City of Surrey
PLANNING & DEVELOPMENT REPORT

File: 7917-0465-00

Planning Report Date: October 7, 2019

PROPOSAL:

Sheet Title
SITE PLAN

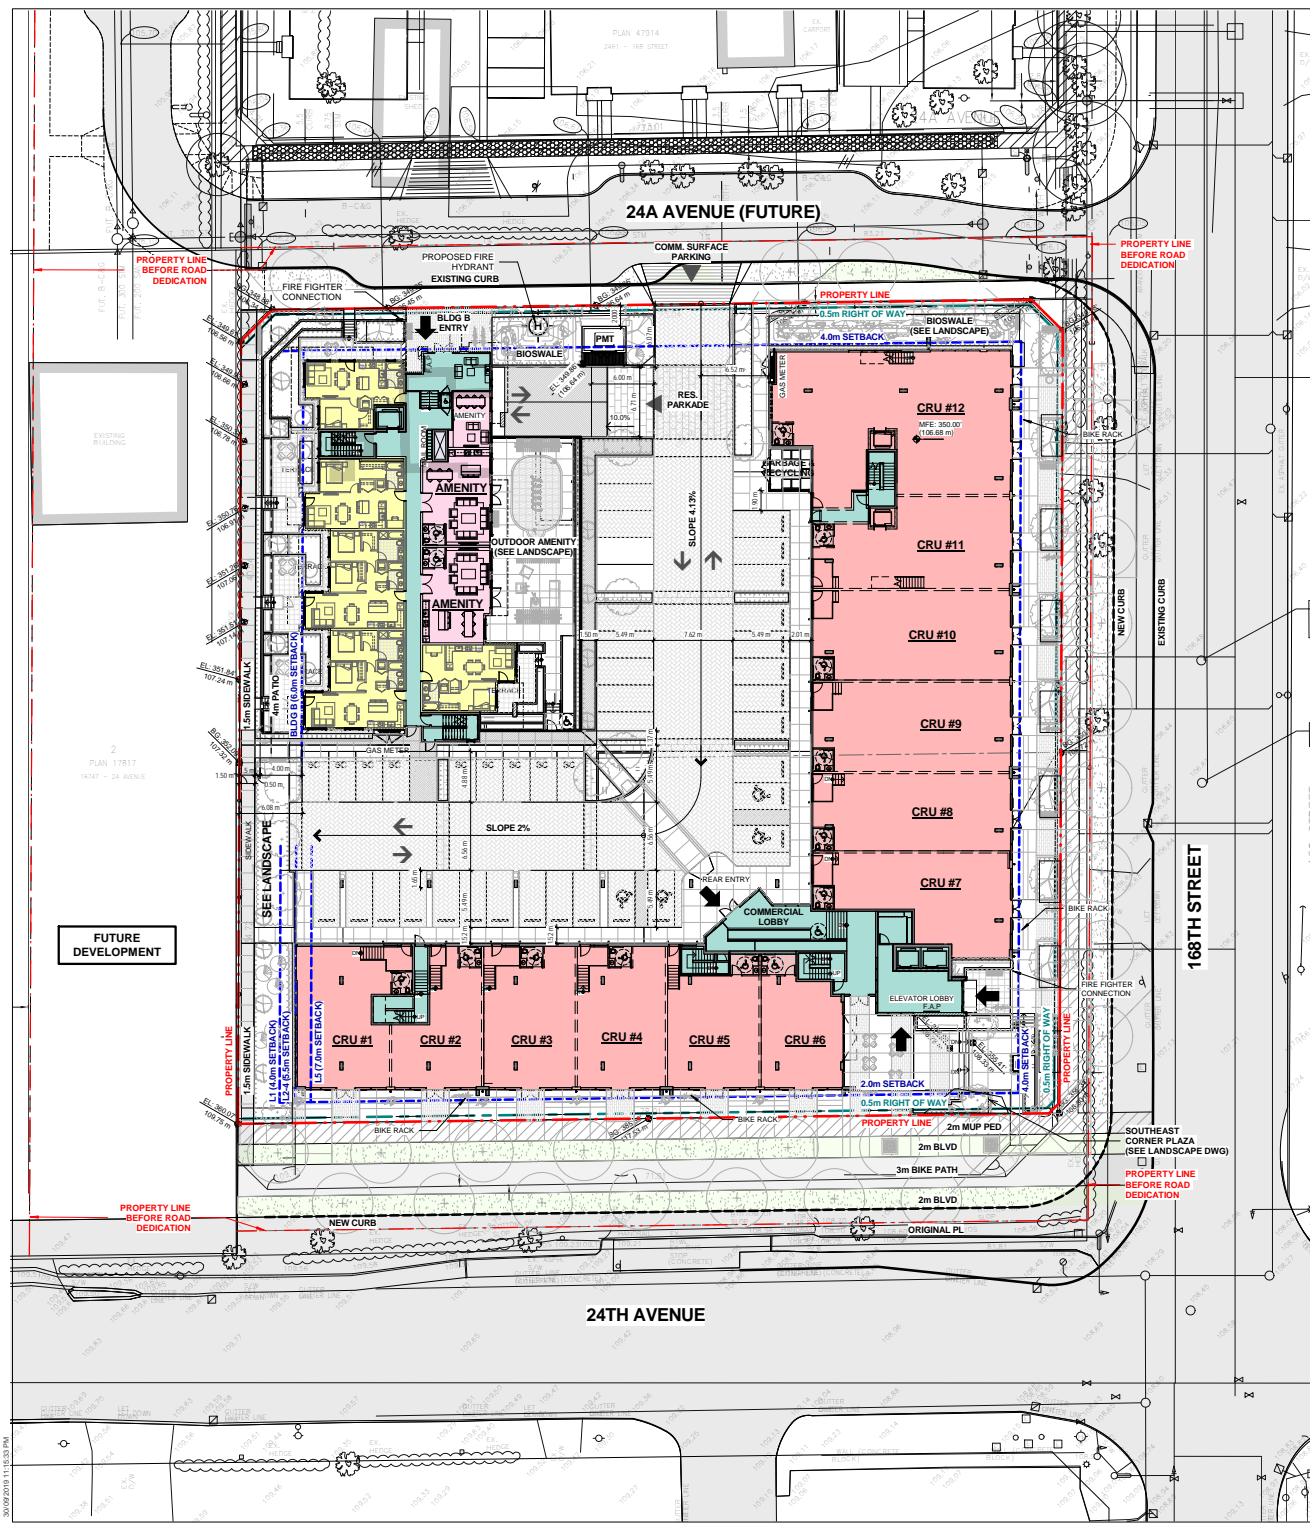
- Review all access into the plaza as the amount of circulation may give the feel of a "transit" space and not a "plaza."
The access to the plaza has been improved by reducing the "south entrance" from Bldg. A lobby. As such, the space that is in front of the "south entrance" could be utilized for seating space and for other public use. See DWG A002 Site Plan & A102 Ground level plan.

Sheet Title
LEVEL P1 PLAN

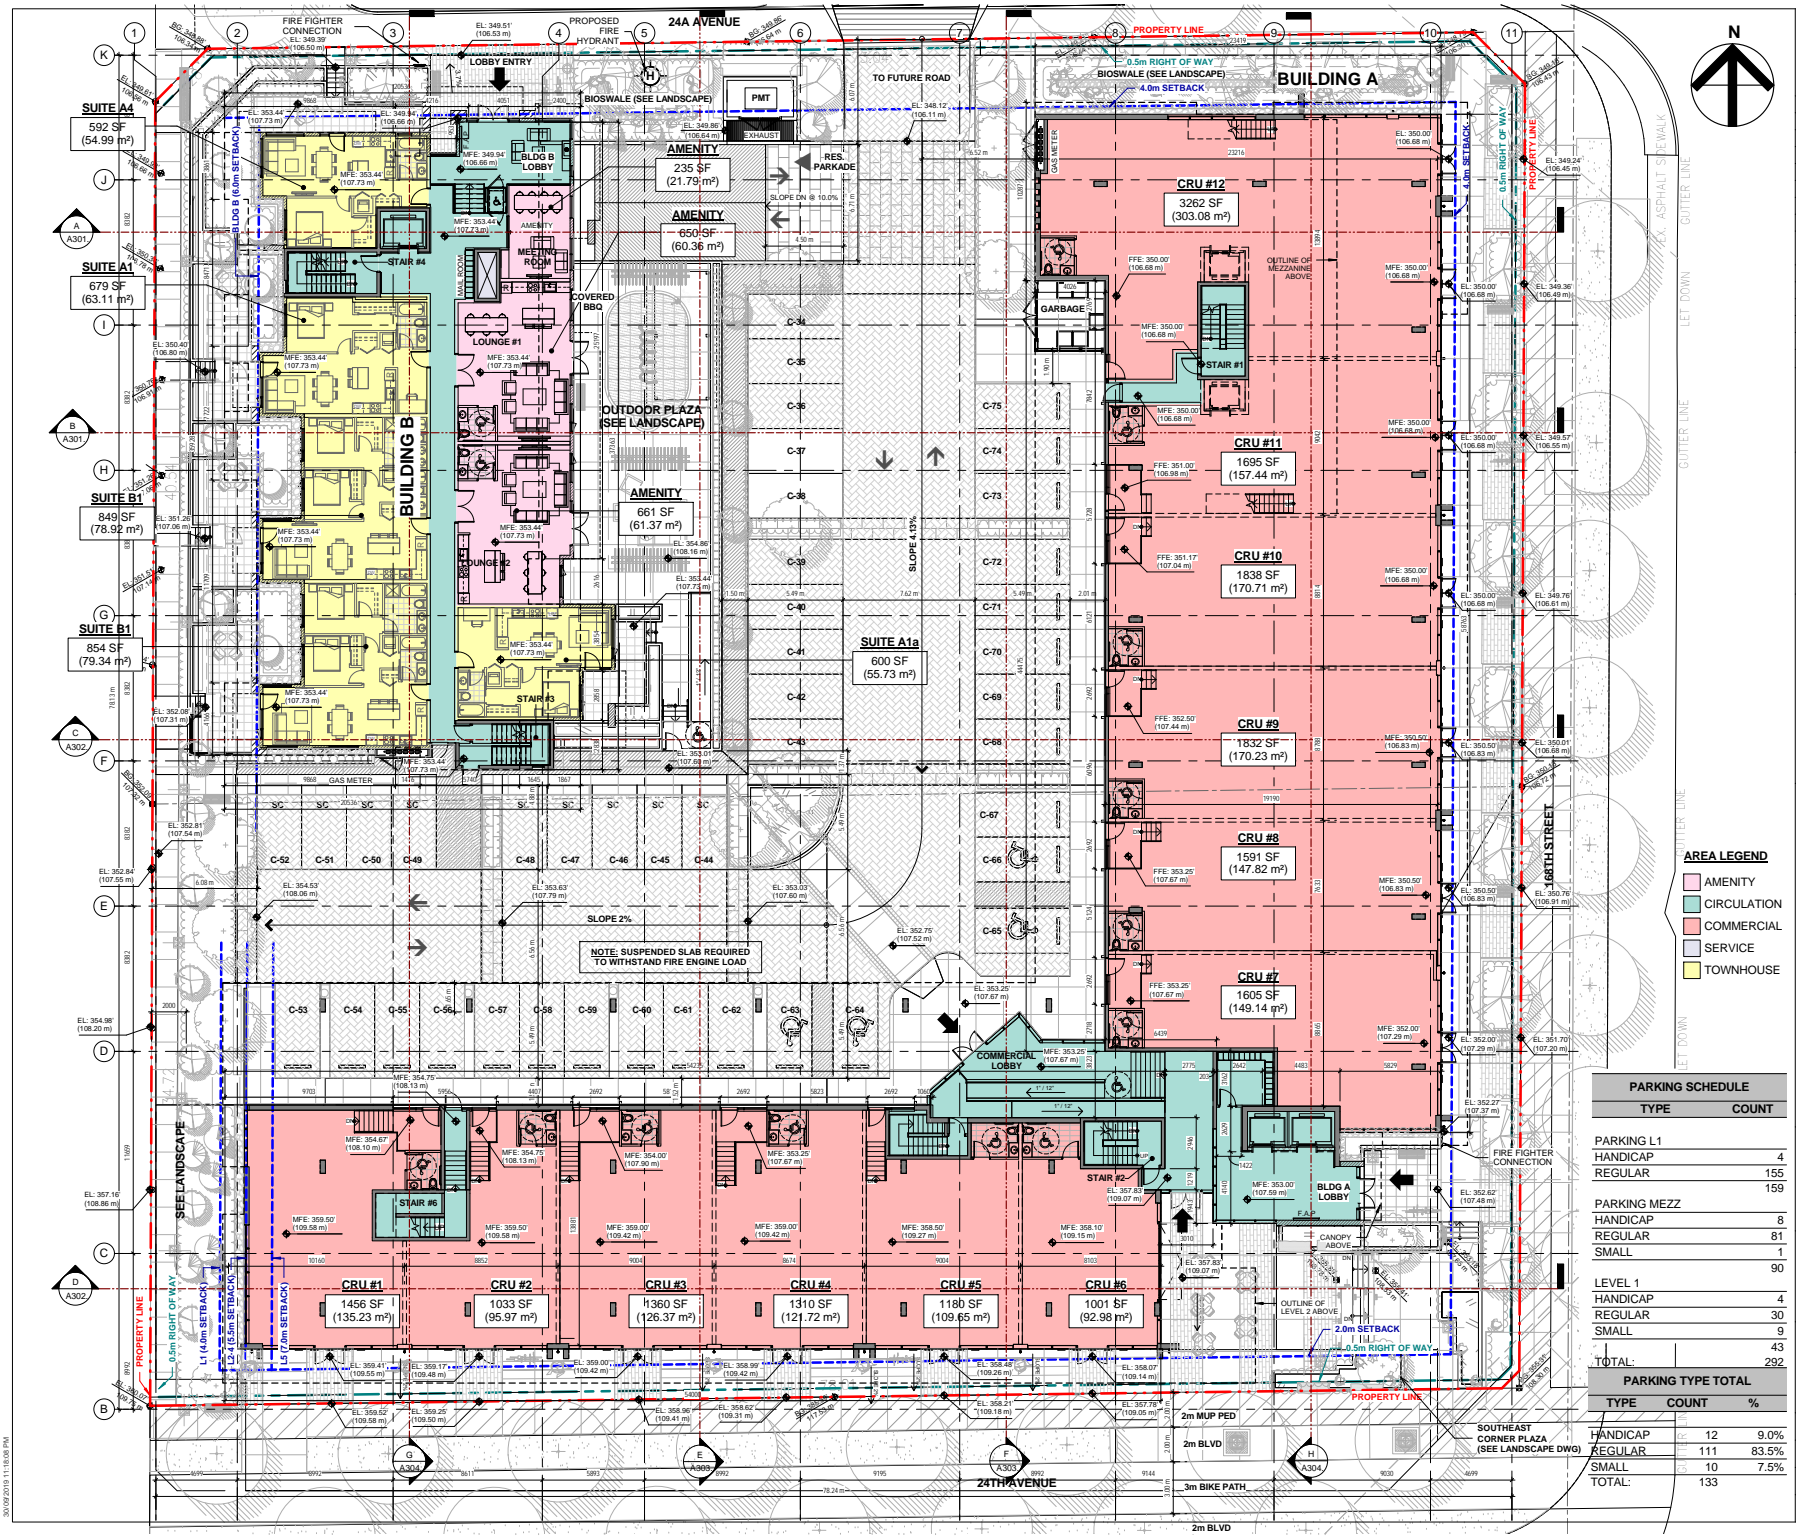
- Consider connecting the interior parkade stair to the mezzanine to provide a choice of vertical access to the parkade.
Implemented. A new stair (#5) is added on the parking mezzanine level for vertical circulation. See DWG A101& A102 GL D & 7.

2: The current location is closer to the surface which is better for ventilation/ exhaust air for the garbage room.
- Consider providing light to the southeast corner amenity room or converting it to a theatres space.
The southeast corner amenity room is programed to accommodate activities like music lesson /practice room (which the users spend a short period of time on them) and a miniature TV room which does not required natural light.. See DWG A101 Parking mezzanine plan.

- Relocate accessible parking stalls in the underground parkade so they have easier access to the mezzanine.
The issued has been resolved by reconfiguration of the parking elevation and removing the steep ramp which provide access issue to the parking mezzanine elevator lobby. There is no height difference between the parking area and elevator lobby currently. See DWG A101GL D& 9.

ISSUE: REVISED 2019

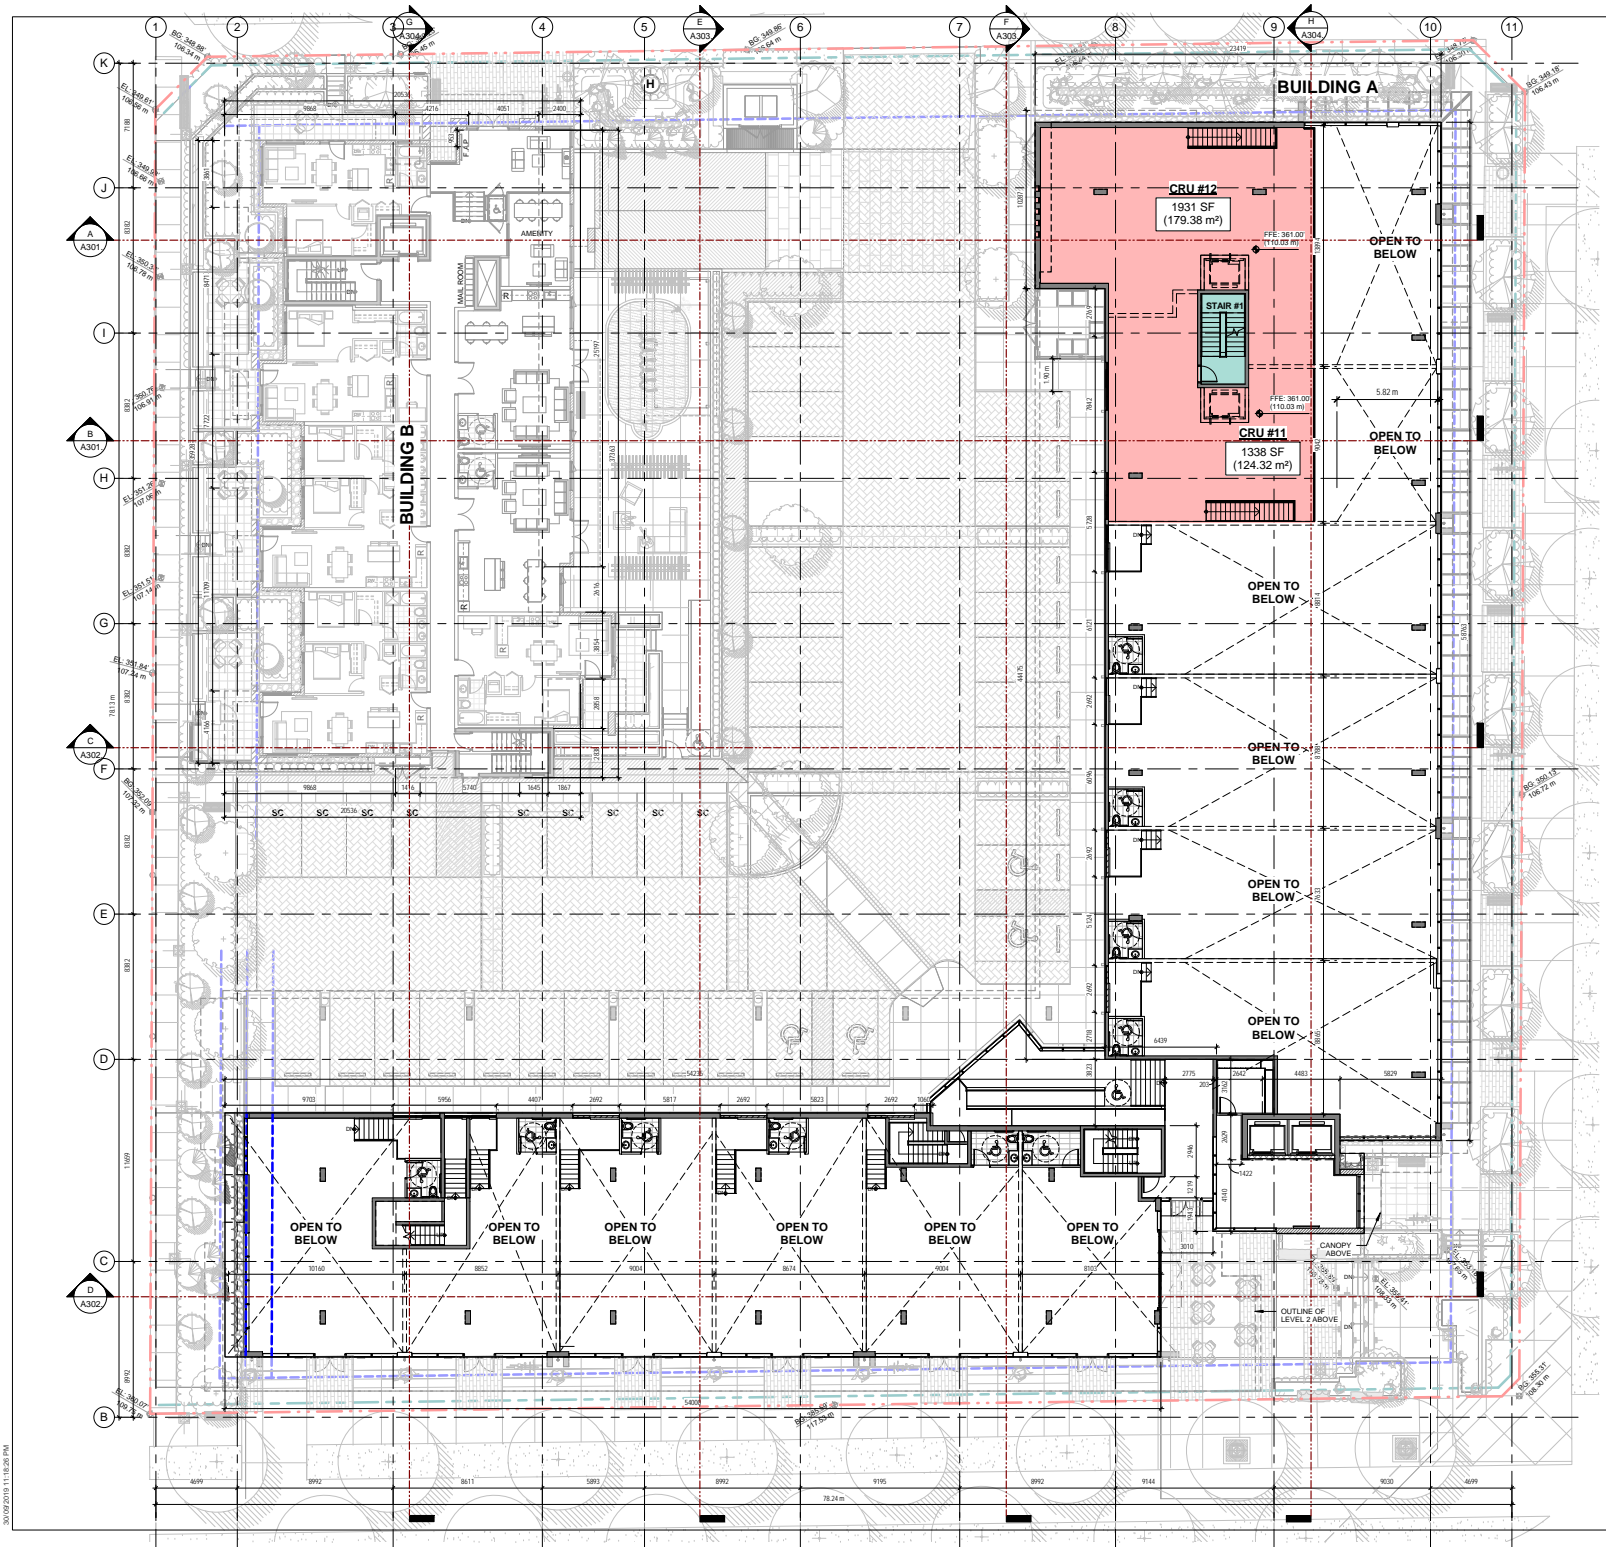
- Suggest a grander door at the side of CRU Unit 6.
A grander overhead door that can roll up/ or an oversized folding door to replace the current proposed storefront door as suggested. See DWG A102 GL C & 8.

- Consider pushing the plaza out to the east and changing the streetscape to provide a grander lobby exit.
The elevation of Bldg Lobby A has been lowered to level with street elevation. In this case, the stairs are eliminated and replaced with grander plaza. The elevator core also has been moved to the north to enhance the lobby with more room as shown. See DWG A102 Ground level plan

- Suggest a generously sized mail room to accommodate large parcel deliveries
The mail room size (was 48 SF) has enlarged from 48SF to110 SF, which is considered a decent size that could accommodate large parcel deliver and storage. See DWG A102 Ground level plan.

SHEET TITLE
T1 - TREE REMOVAL AND PRESERVATION PLAN

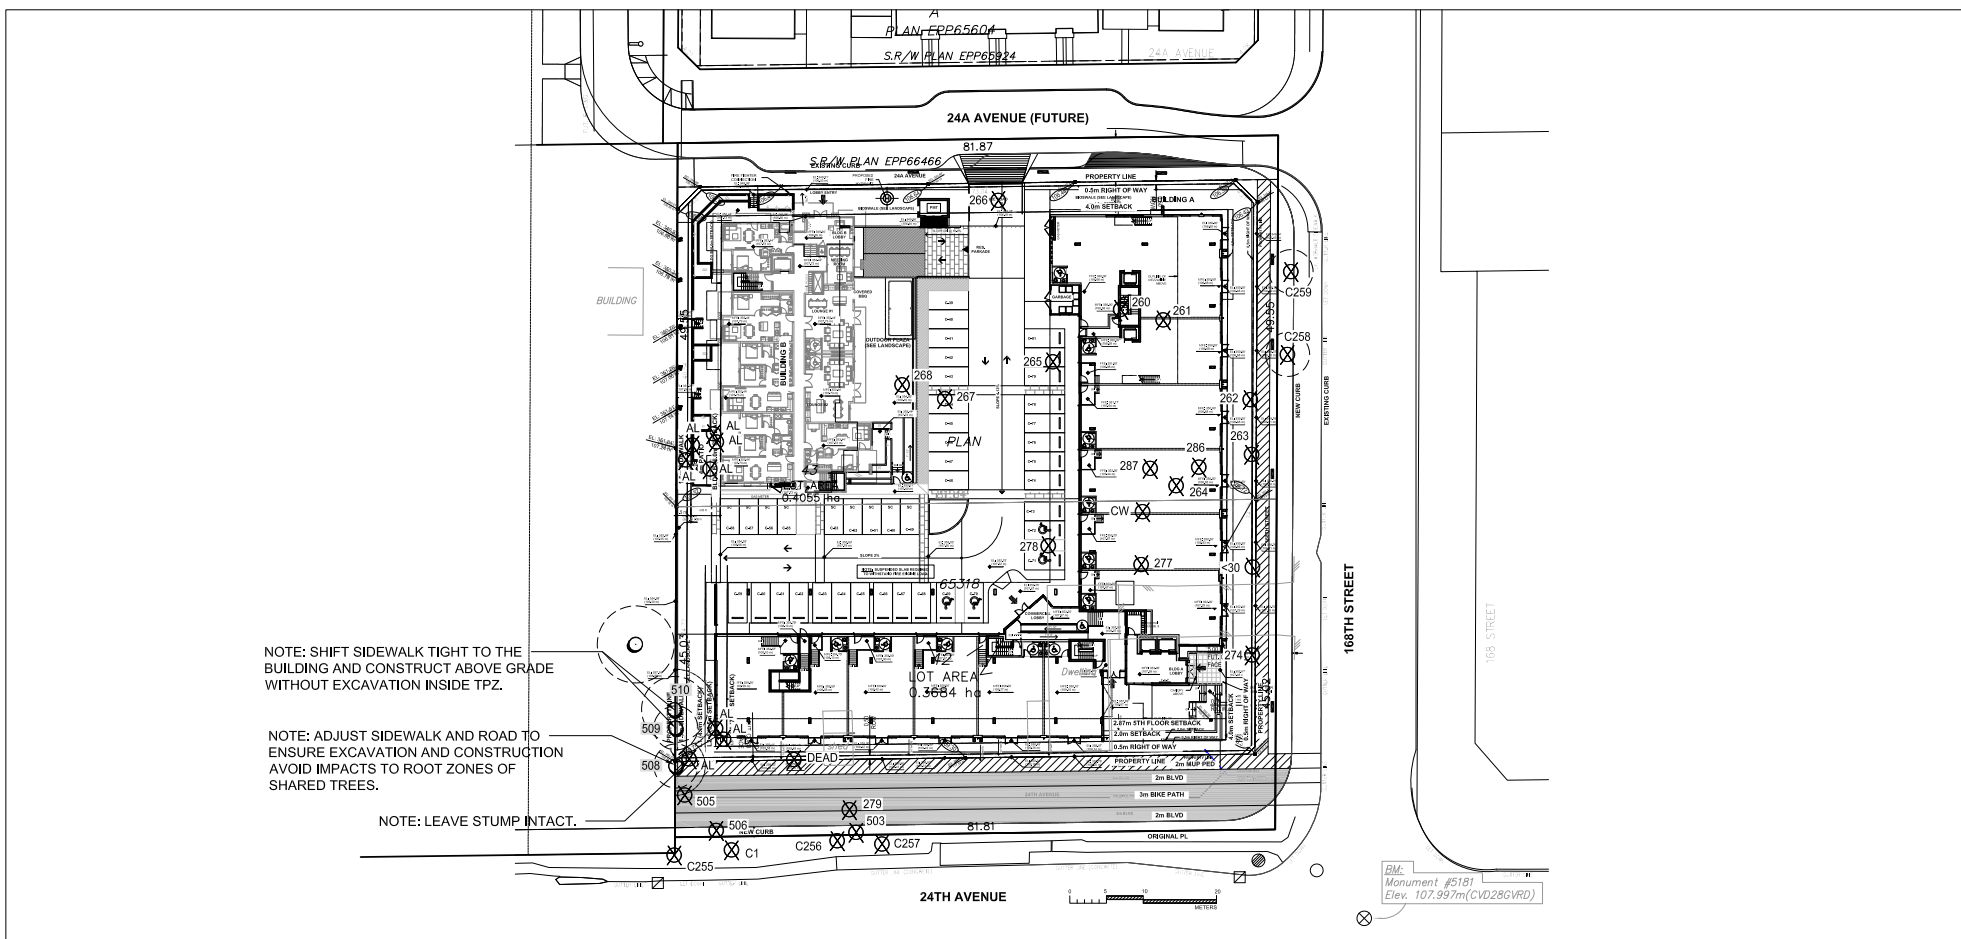
NOTE: SHIFT SIDEWALK TIGHT TO THE BUILDING AND CONSTRUCT ABOVE GRADE WITHOUT EXCAVATION INSIDE TPZ.
